47 Doughty Street,  
London, WC1N 2LW

Basement Impact Assessment  
Audit

London Borough of Camden

Project Number: 12336-40  
Revision: D2

E&P  
SK16  
Structural details of Basement Junctures  
2017.02.15 JET

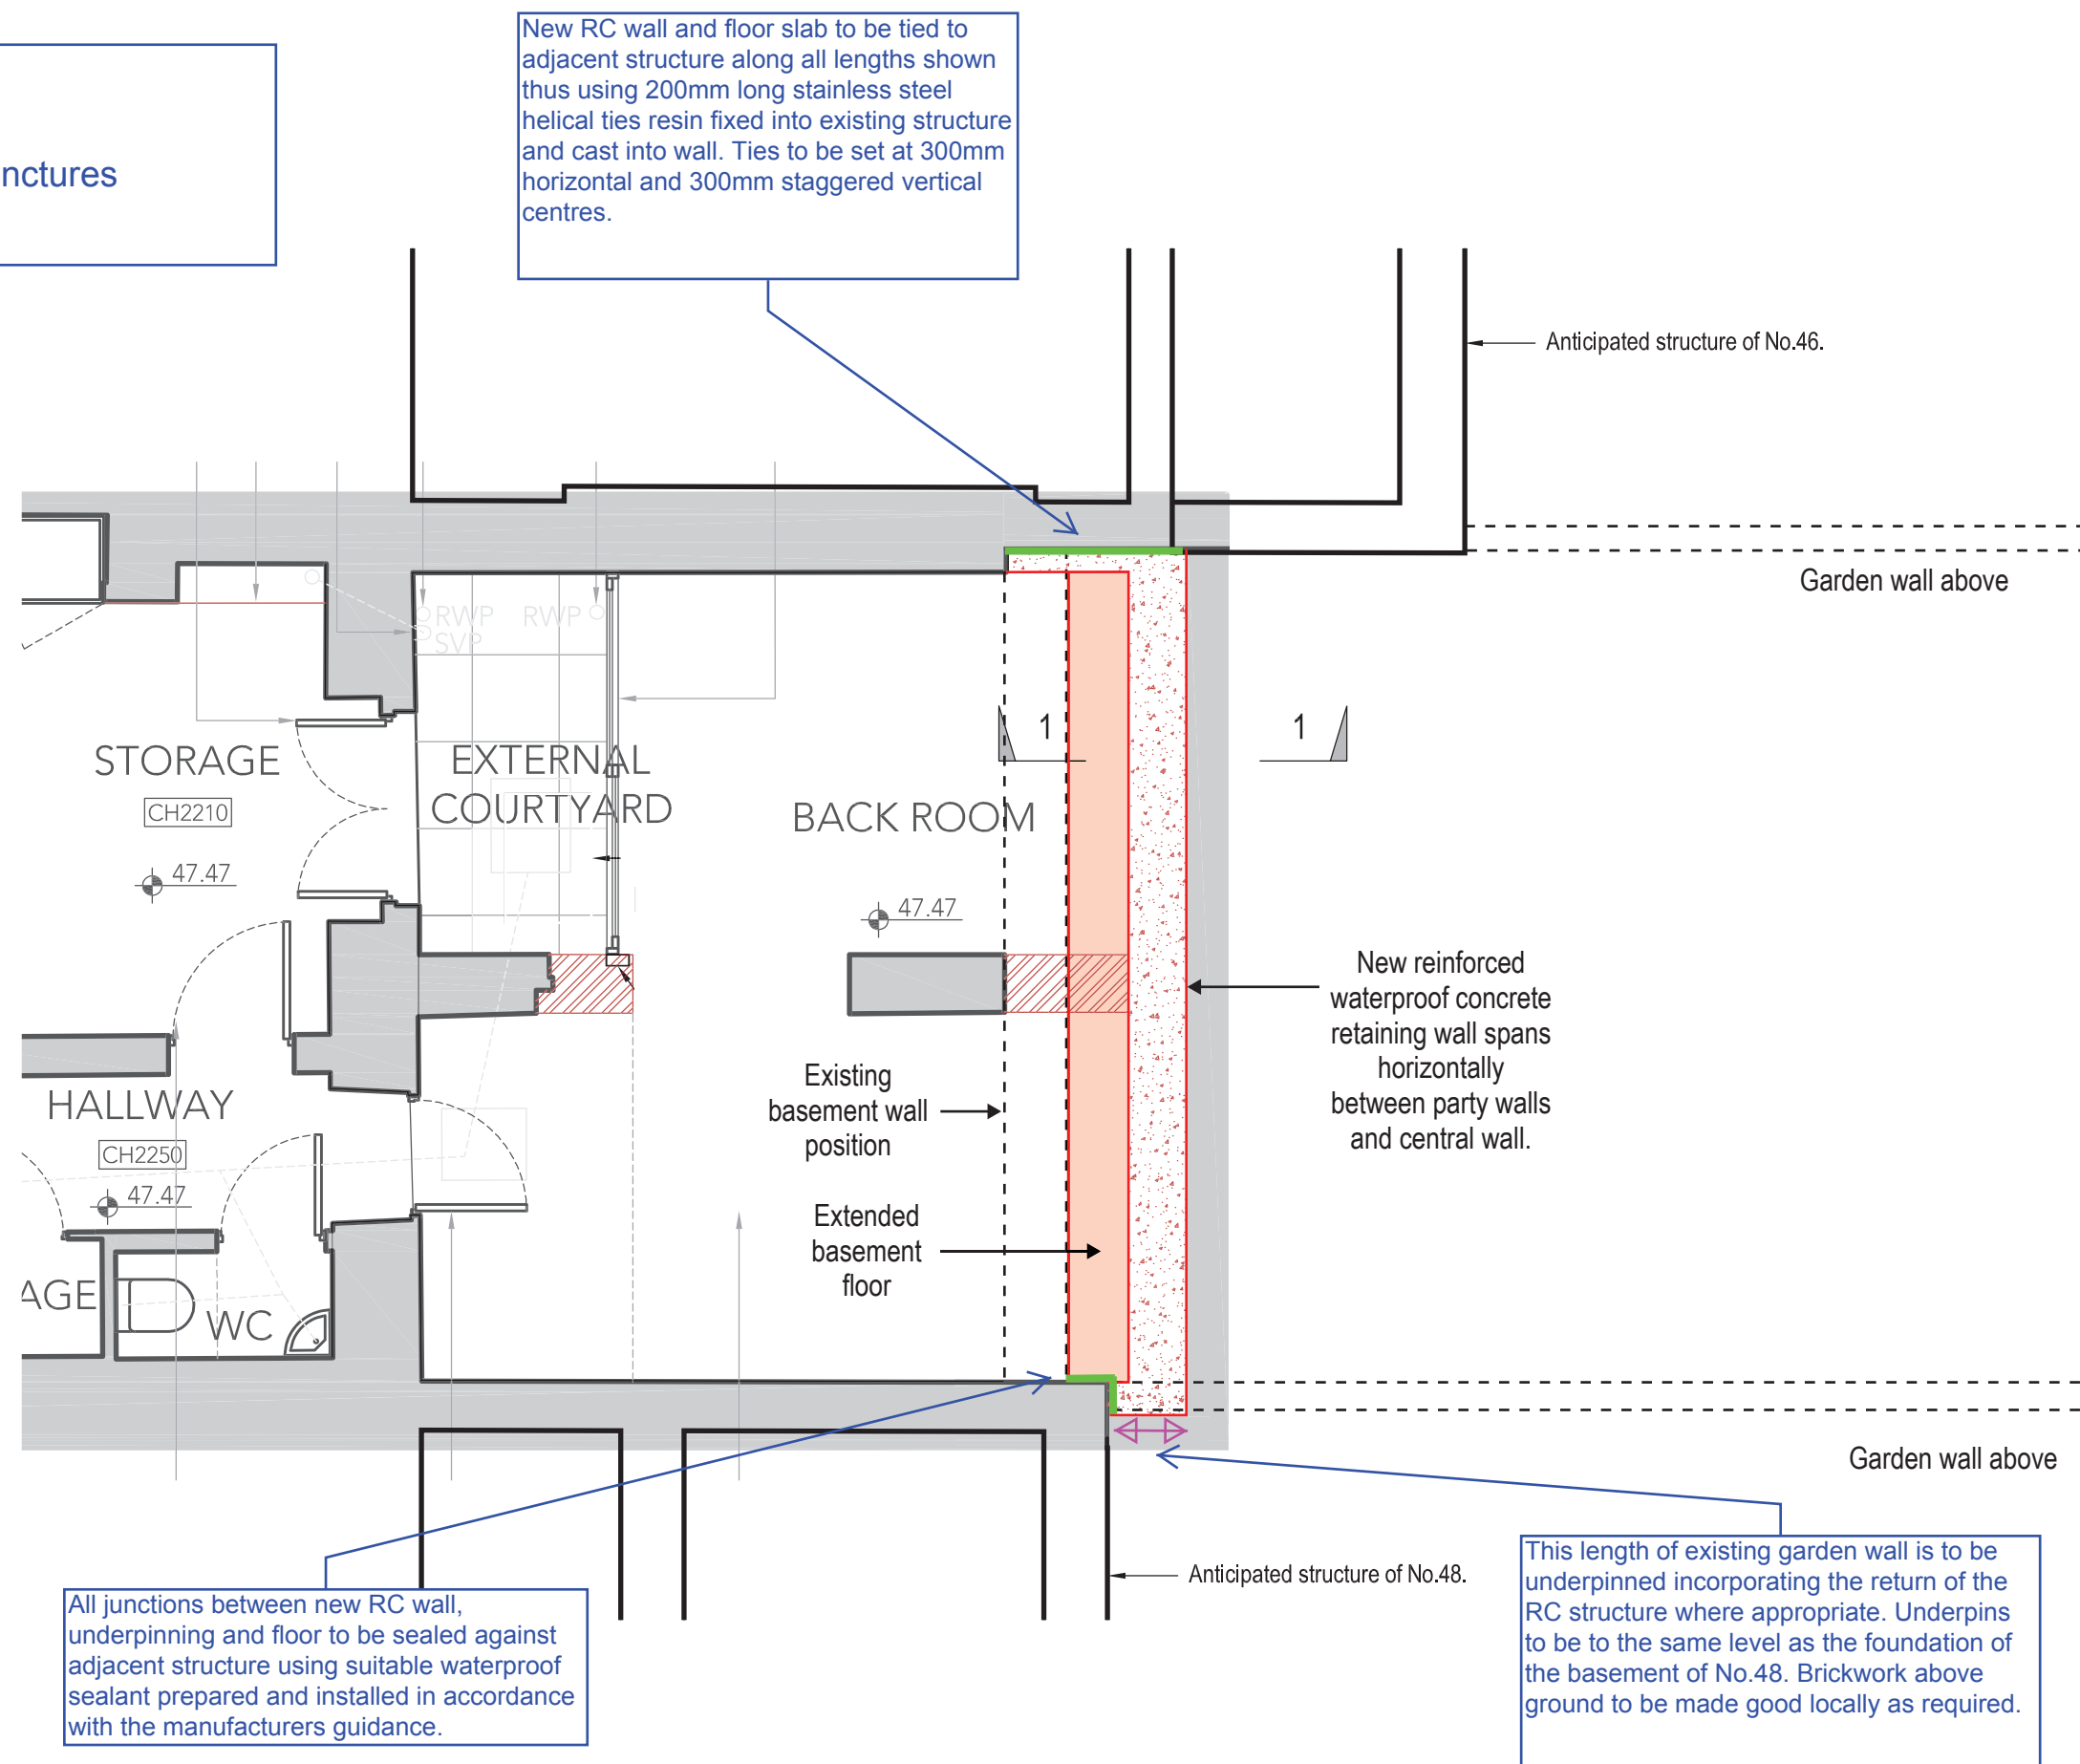
*2) Please provide calculations for the design of the new retaining wall, including proposed connection details to both the Party Walls and all associated temporary works proposals and construction sequencing drawings.*

Calculation pages BW 1-4 are attached in Appendix B together with a copy of SK 16 which provides structural details of the basement junctions. More detailed CAD drawings will be produced in due course. We have also attached a copy of our Temporary Works Proposal
